Wates Developments
Land adjacent to Deeping Road, Baston, Lincs

Formal Response to Consultee Comments

July 2026 (Revision A)

LAND ADJACENT TO DEEPING ROAD, BASTON, LINCOLNSHIRE
FORMAL RESPONSE TO CONSULTEE COMMENTS
JULY 2026 (REVISION A)

DRAWN BY	
NAME (PRINT)	DATE
DS	09.12.22
CHECKED BY	
NAME (PRINT)	DATE
CJB	09.12.22
SCALE	1:500@A3
STATUS	PRELIMINARY
DRG. NO.	F20159/03
REV	C

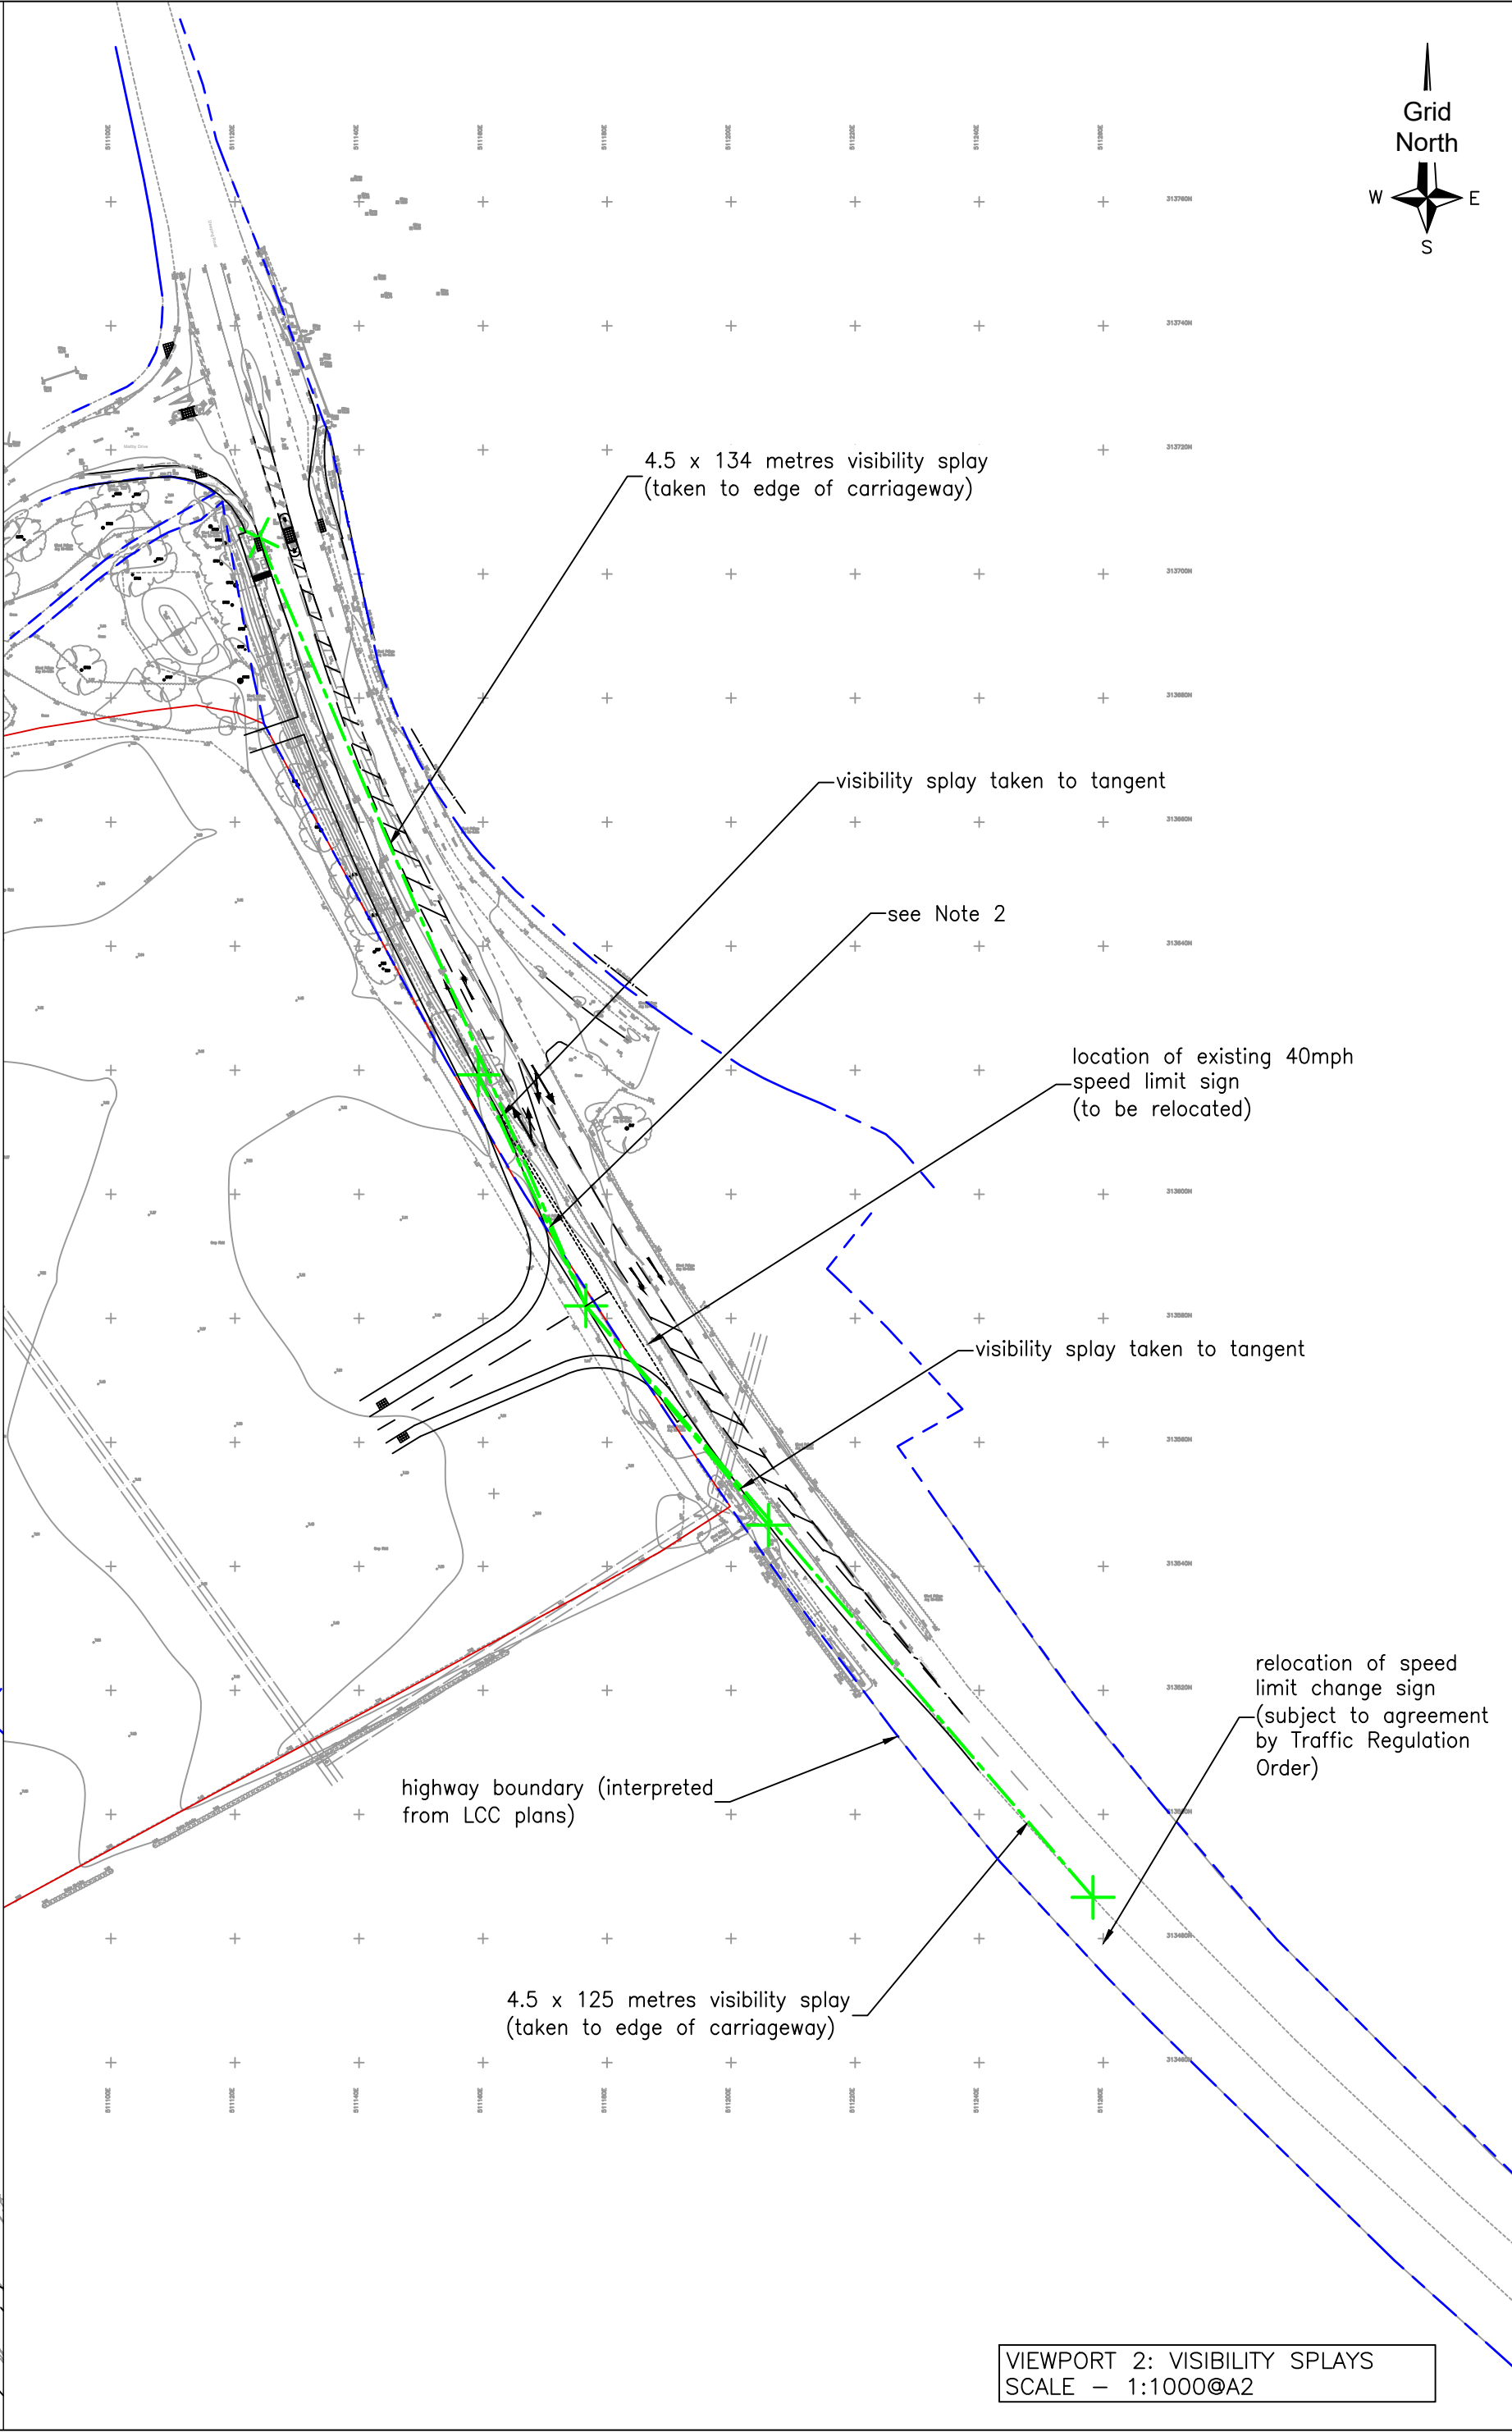
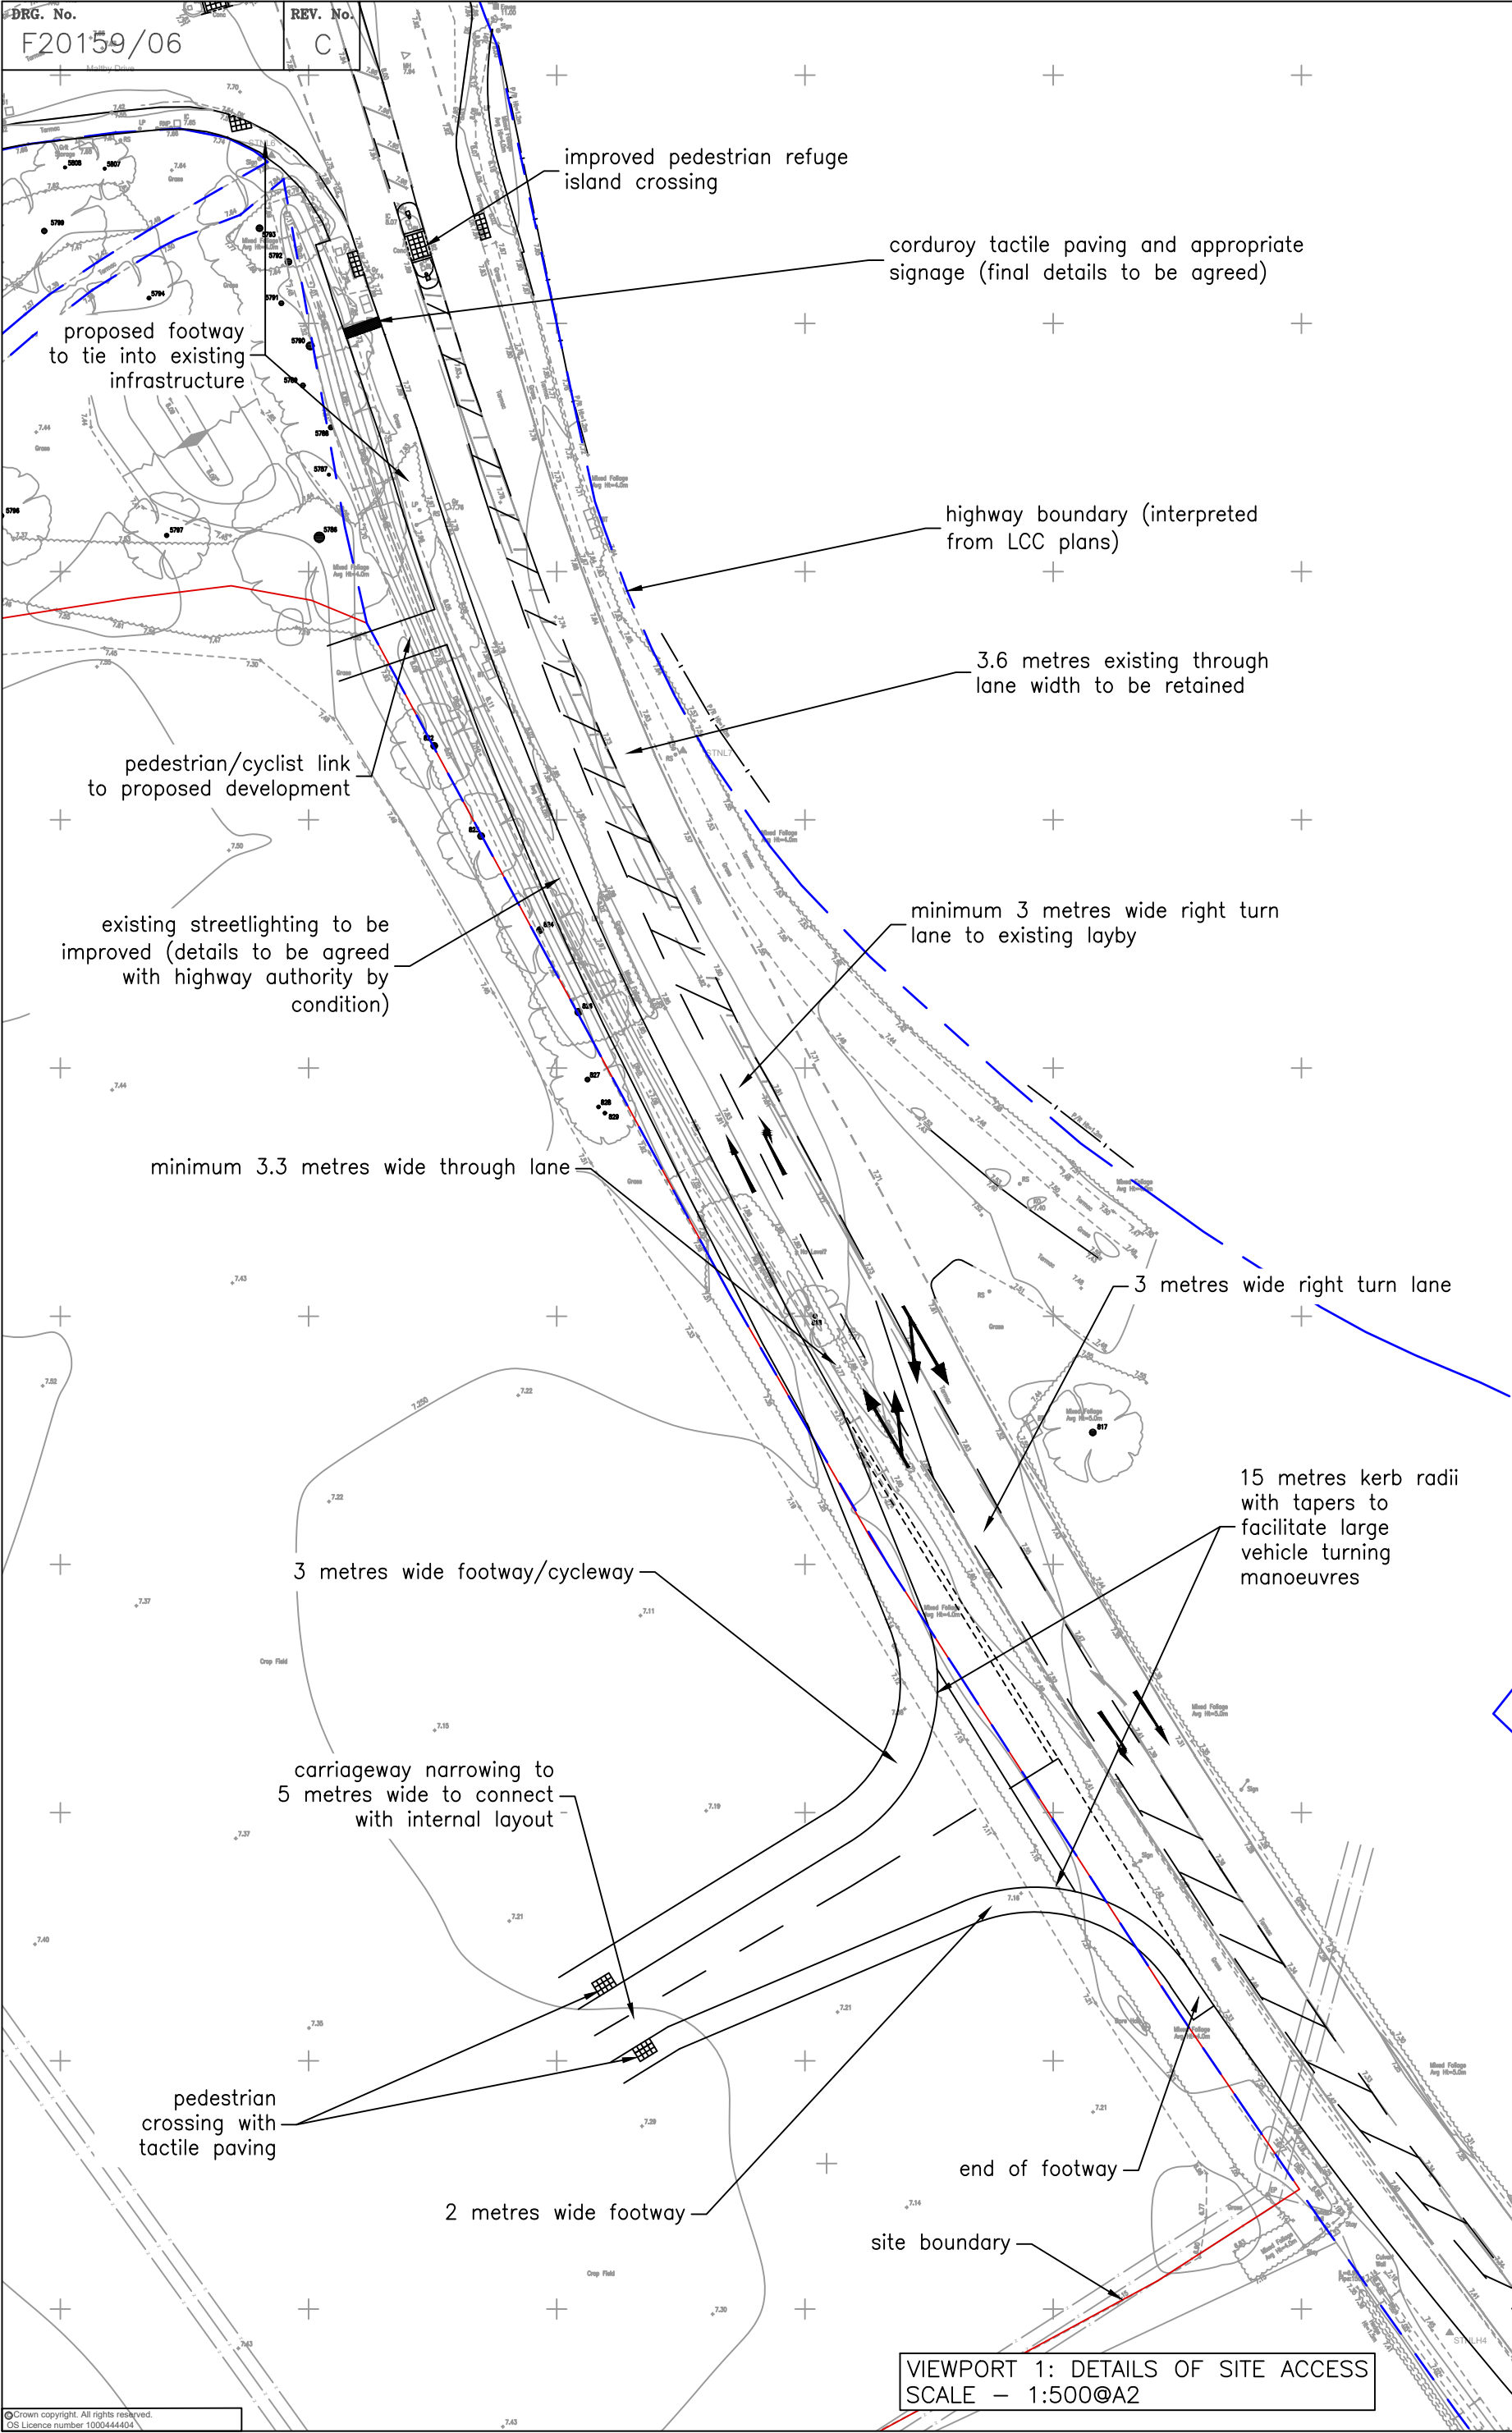
Reduce width of access onto Greatford Road to 5m with a 6m radii - Greatford Road can be widened to accommodate swept paths.	<i>As above, this point was discussed at the meeting with LCC and Drawing Number F20159/03 Revision C now shows the updated junction layout with Drawing Number F20159/07 Revision A demonstrating the updated vehicle tracking assessment.</i>

- **Residential Travel Plan (Revision C)** – includes LCC comments on delivery details.
 - **Drawing Number F20159/03 Revision C** – amended to include 5 metres wide access and labelling for future streetlighting.
